**9.1 NO. 81 (LOT: 117; D/P: 2099) EAST STREET, MOUNT HAWTHORN - PROPOSED ALTERATIONS AND ADDITIONS TO SINGLE HOUSE**

To consider an application for development approval for alterations and additions to a single house at No. 81 East Street, Mount Hawthorn (the subject site).

**Figure 1 – Comparison of shadowing from Family Wall & existing dividing fence**

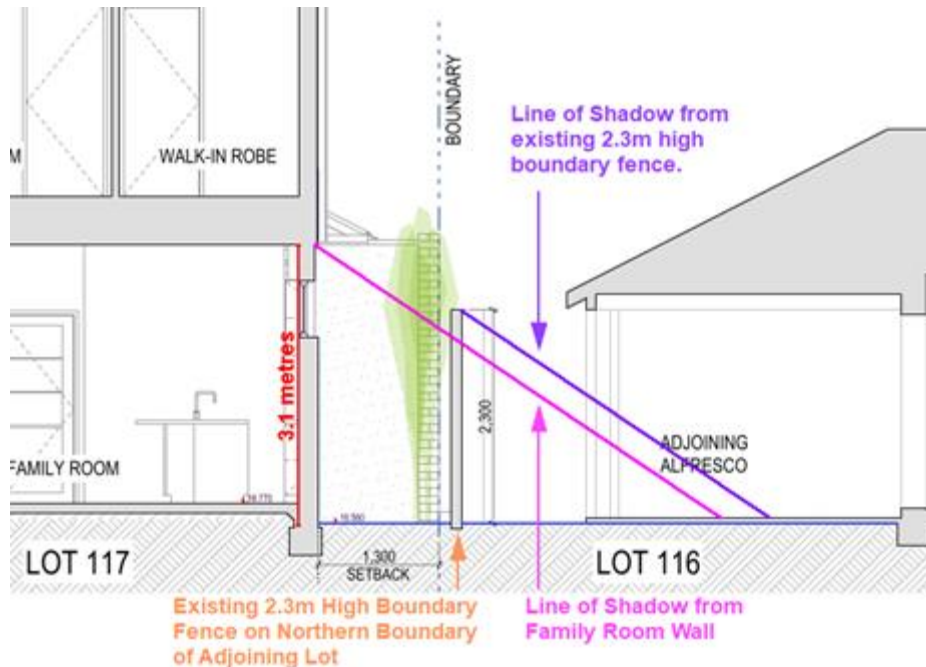
- Impact on Solar Access:** The total amount of overshadowing would comply with the deemed-to-comply standard of the R Codes. Notwithstanding this, the proposed wall to the Family Room that does not meet the lot boundary setback deemed-to-comply standard would not reduce the amount of sunlight provided to the southern adjoining property. This is because the shadow that would be cast by this wall would fall on the existing 2.3 metre high boundary wall. This existing boundary wall itself would cast a greater shadow compared to that from the Family Room wall, as shown below in **Figure 1**. This figure shows the shadow cast on 21 June at winter solstice when shadowing is at its worst, as per the deemed-to-comply standard in the R Codes.

Site plan/shadow diagram. Orange shading indicates existing overshadowing, predominantly caused by 2.3m high brick rendered wall contained within Lot 116. Proposed overshadowing in blue shows it'll mostly overlap with existing shadow, or cast over the roof of adjoining dwelling on Lot 116.

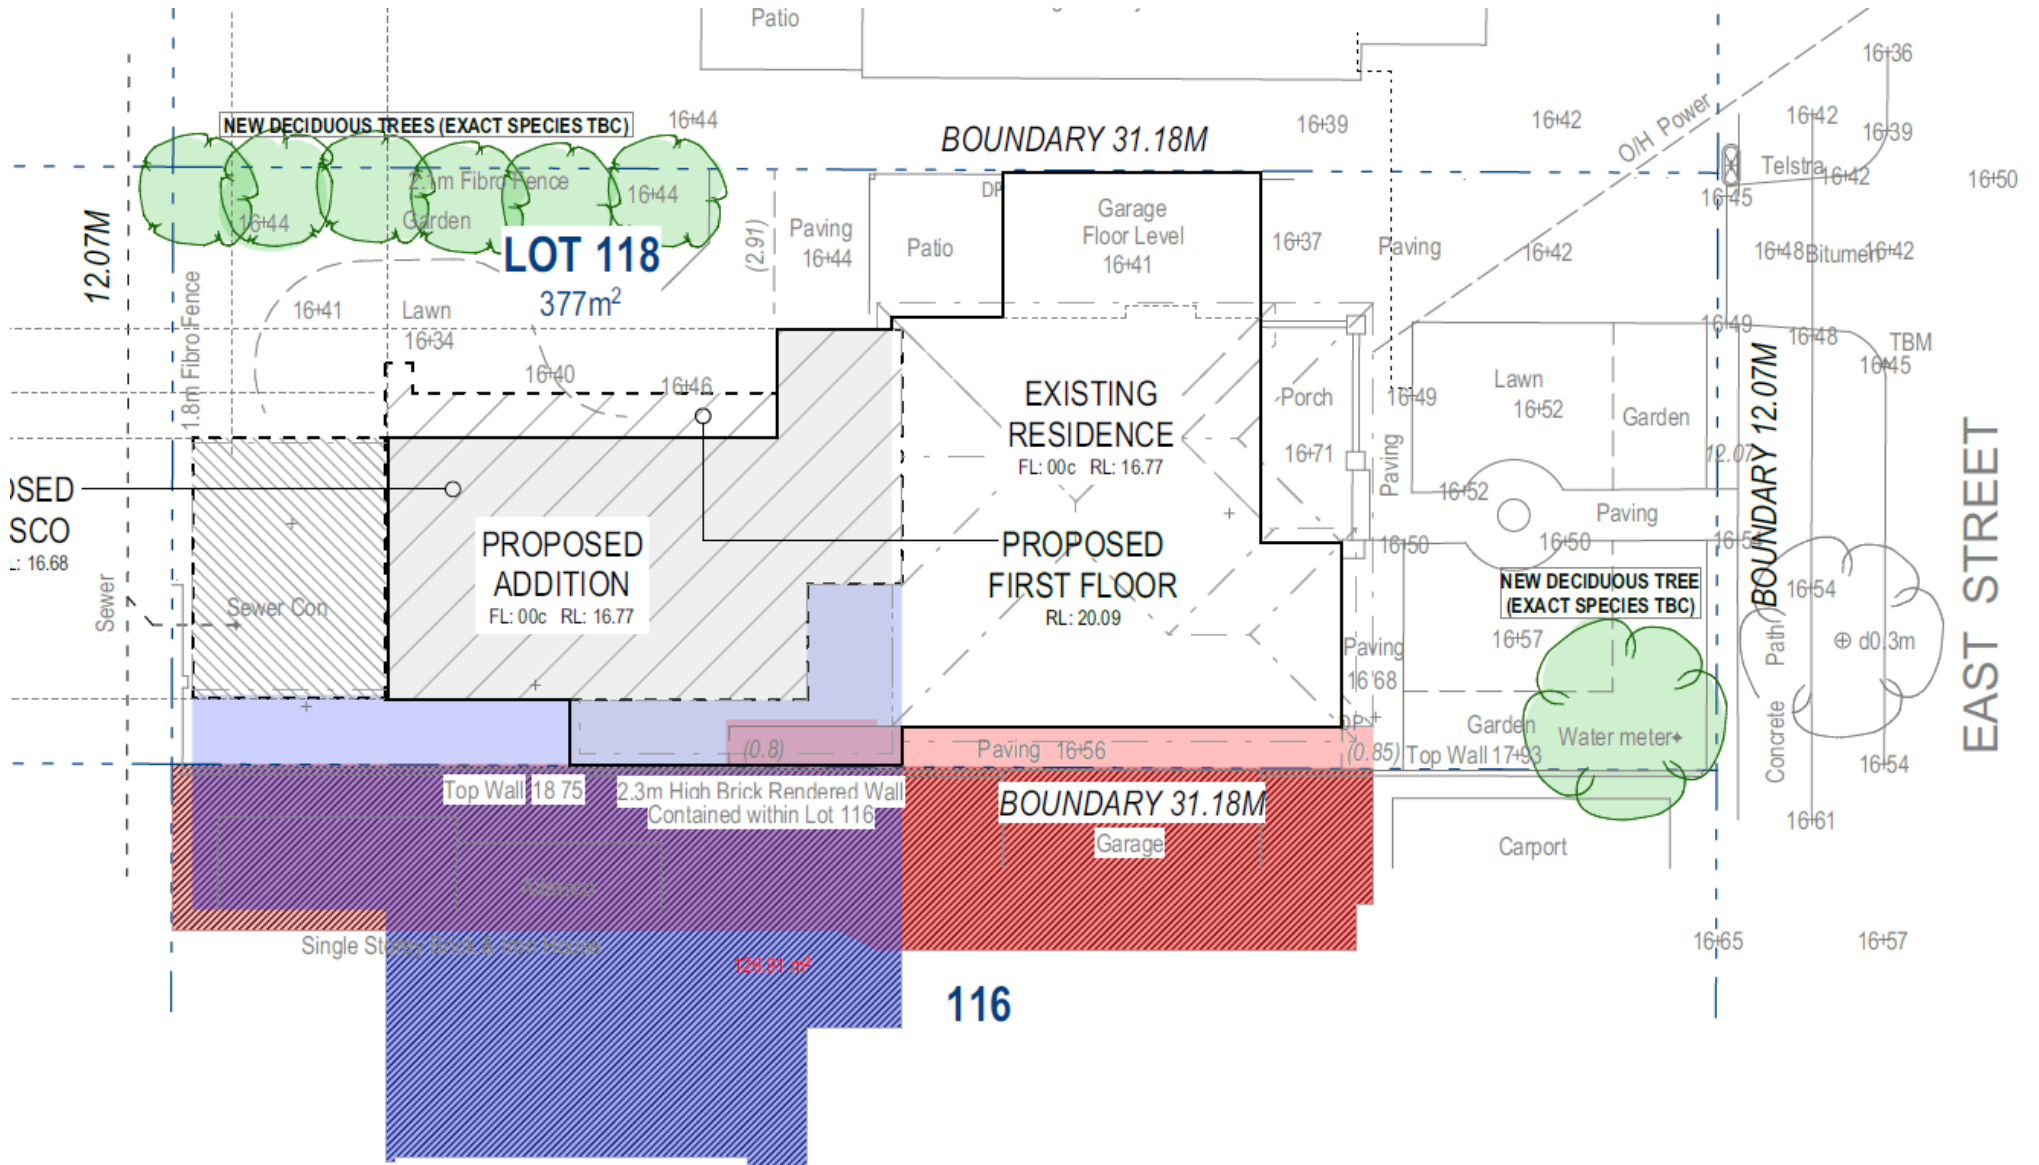
<p><u>Design</u></p> <ul style="list-style-type: none"> <li>• The shipping box design and black colour of the development is inconsistent with the character of the street and surrounding area and will significantly impact the street and adjoining properties</li> <li>• The box design of the additions is not appealing to look at</li> <li>• The style is taking away from the federation style of Mt Hawthorn.</li> <li>• Design of the development provides an adverse precedence to the area and encourages "concrete jungle"</li> <li>• The black colour of the development will loom over adjoining properties.</li> </ul>	<ul style="list-style-type: none"> <li>- Contrasting a traditional dwelling with a modern/contemporary addition is not an uncommon approach and respects the integrity and character of what's currently in place. It is the standard practice when dealing with heritage-listed building fabric as it is important to distinguish original/significant elements from a latter-day addition. Doing a 'mock heritage' addition would devalue the original home as dwellings of such scale in such setting would be highly unusual in the 1940s.</li> <li>- 'Not appealing to look at' is highly subjective. While we do not claim to be arbiter of taste, we are well-regarded within the construction industry, being the most award-winning renovation builder in WA.</li> <li>- Appearance of original dwelling, including the main roof line is preserved. We recognise the character of the locality and opted to respect the original built form by not proposing to build over the original house.</li> <li>- The black metal cladding only appears on elevations that are set back from the boundary and not "loom over adjoining properties". On the South elevation, external walls would mostly be rendered in Dulux 'Vanilla Quake', a soft, warm neutral.</li> </ul>
